**FINAL DRAINAGE REPORT
FOR
STIMPLE SUBDIVISION
FILING NO. 1**

CCES Responses

Job No. 1185.80

PCD Project No. SF-24XX

SAND CREEK DRAINAGE
 BASIN PLANNING STUDY
 PRELIMINARY DESIGN PLANS

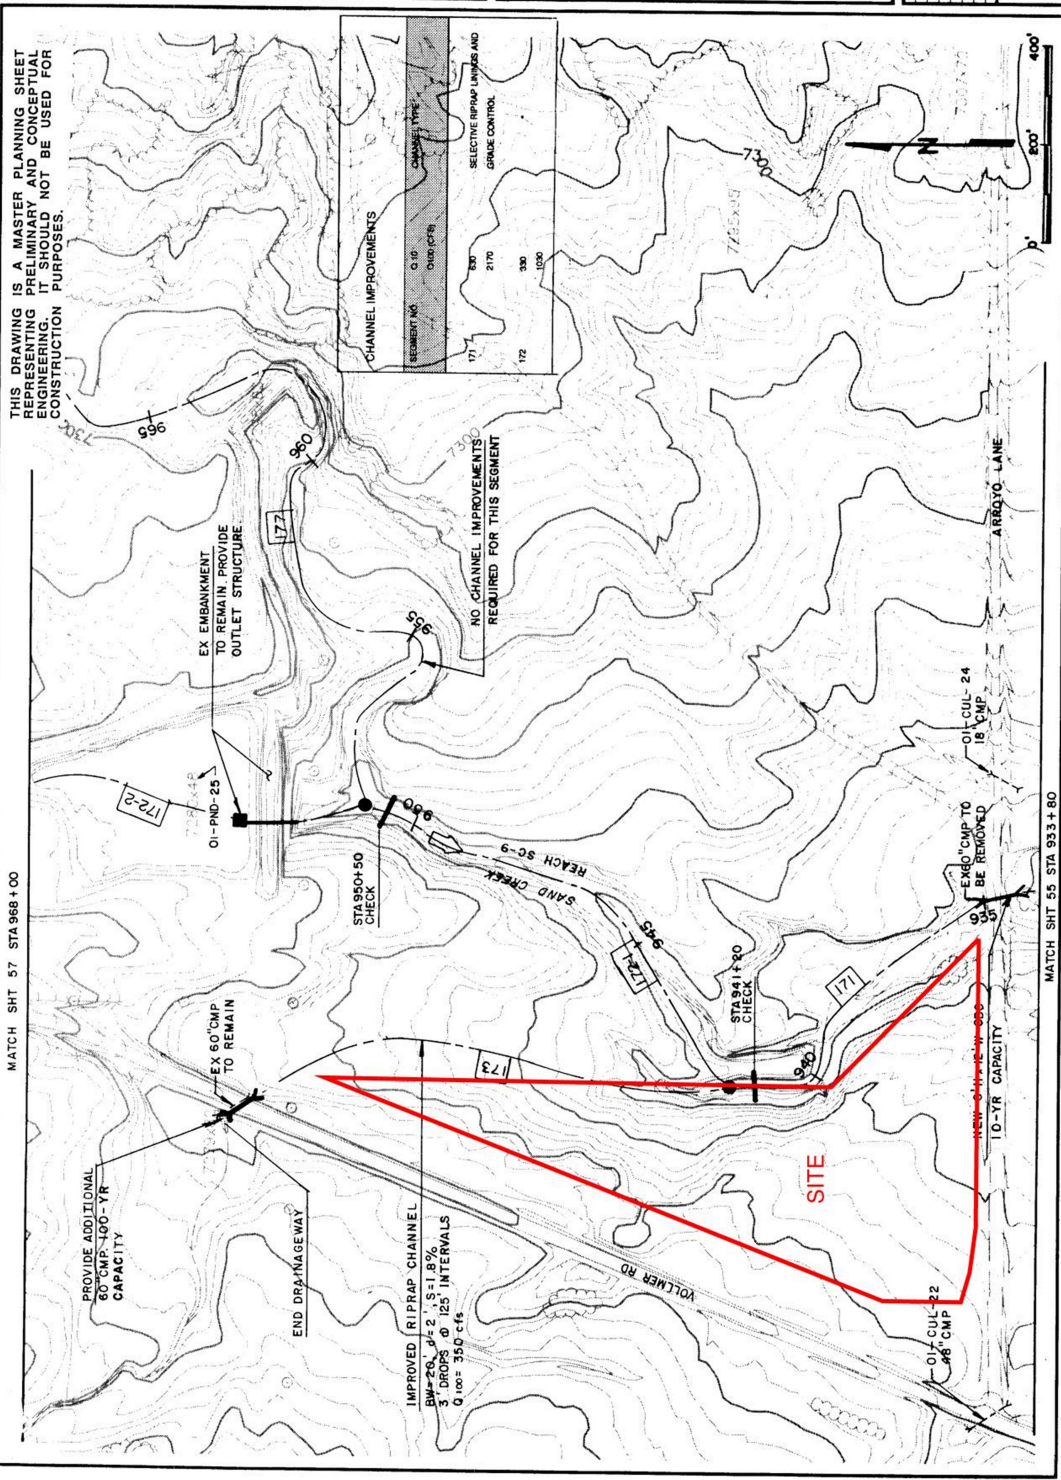
Not sure why this was highlighted??

STIMPLE SUBDIVISION FILING NO. 1
FINAL DRAINAGE REPORT
 DEVELOPED DRAINAGE MAP

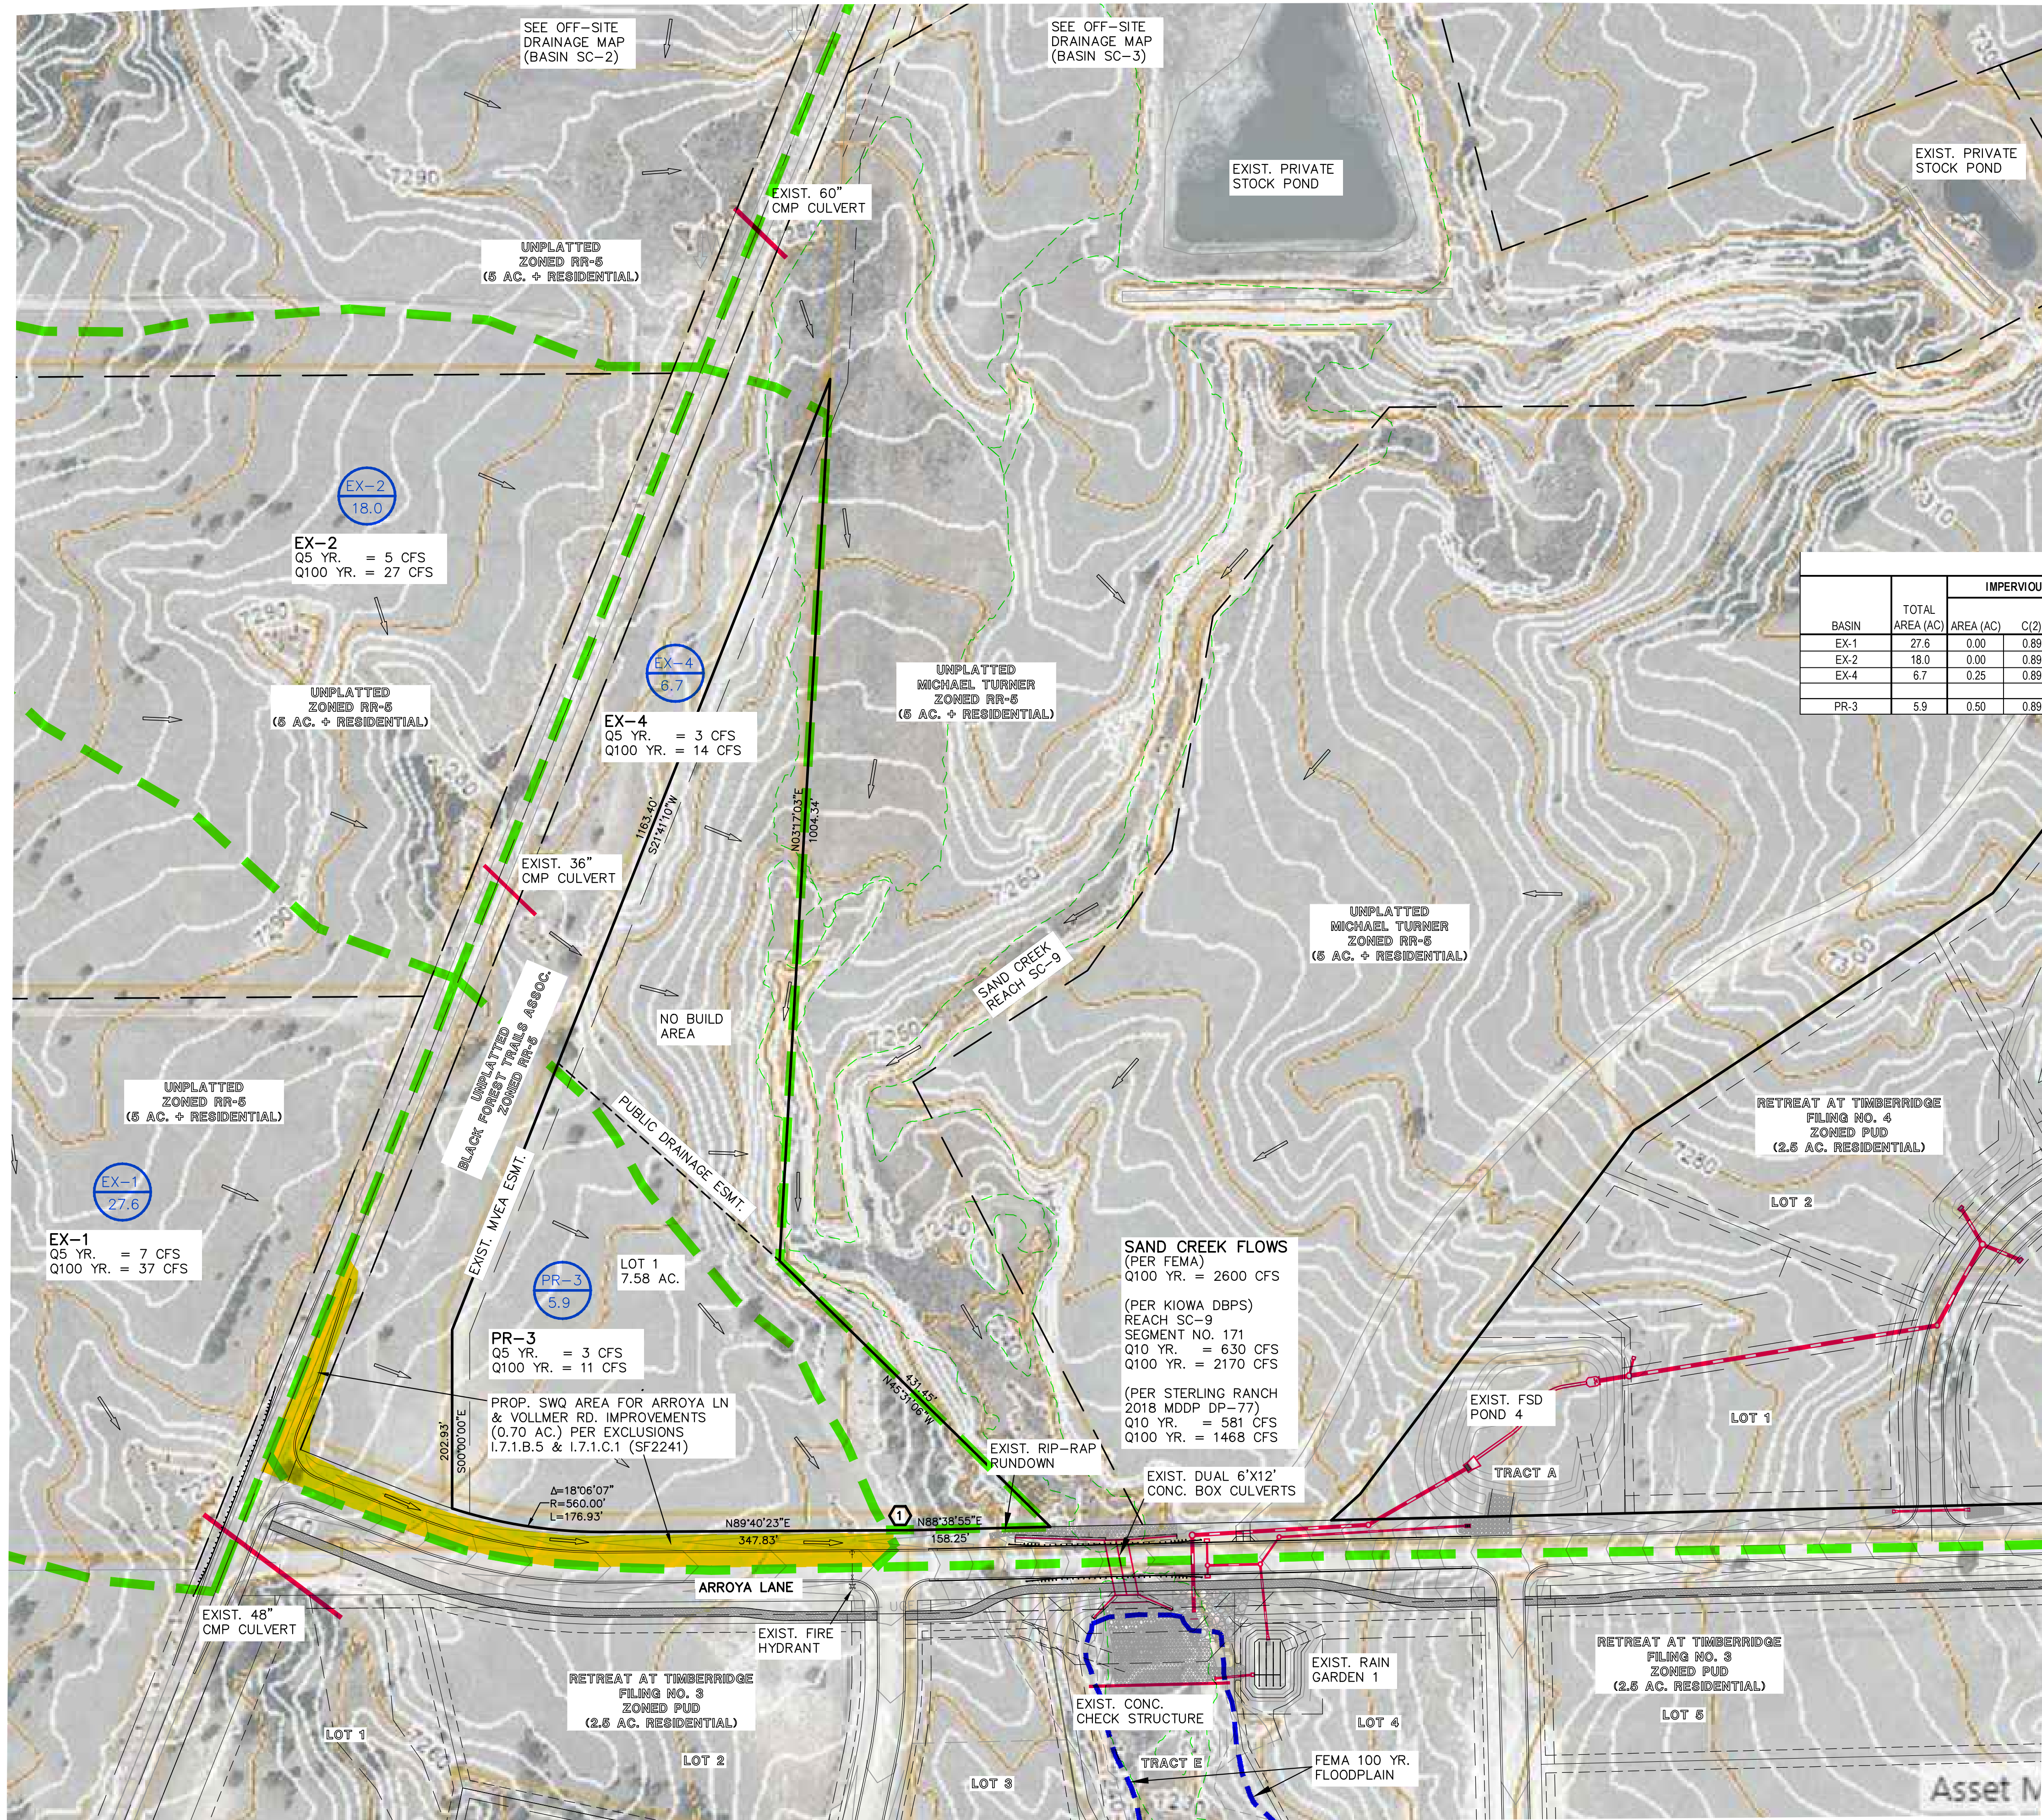
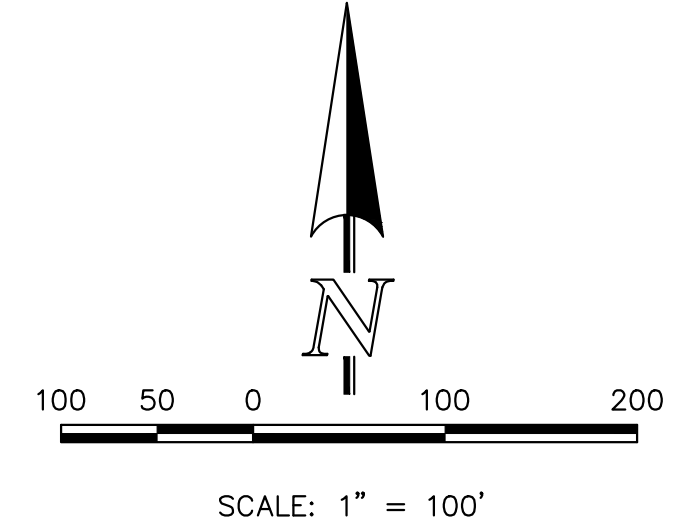
See revised basin calcs.

See above comments, the impervious restrictions need to be discussed to apply I.7.1.B.5

This is a 7.5 ac. lot with only one home proposed. The lot itself is under the 10% imp. The reason Basin PR-3 has an imp. % greater than 10% is due to the adjacent Vollmer and Arroya Lane roadways. We have now adjusted the basins to show how the lot itself with a single unit is less than 10% imp. See revised calcs.

See revised basin calcs.
